Memorandum

Subject: Review of Z2026000119
Applicant Name: Cape Summit 69 Holdings LLC

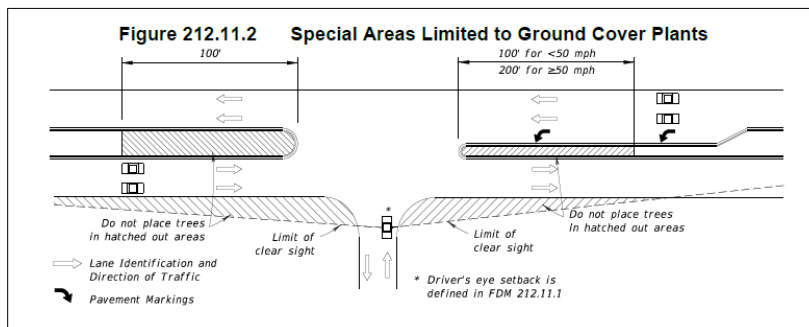
1. Exit driveways must comply with clear sight visibility requirements for both pedestrians and vehicular traffic. Provide clear sight visibility triangles on the site and landscape plans

to demonstrate compliance with these requirements. Please ensure to clearly illustrate both (pedestrian and vehicular) sight triangles following the MDC Traffic Operations Manual and FDOT Standards. Note that according to the latest FDOT FDM manual Section 212.11.6, trees may not be placed within the hatched-out areas of the sight triangles, as shown in the figure below.
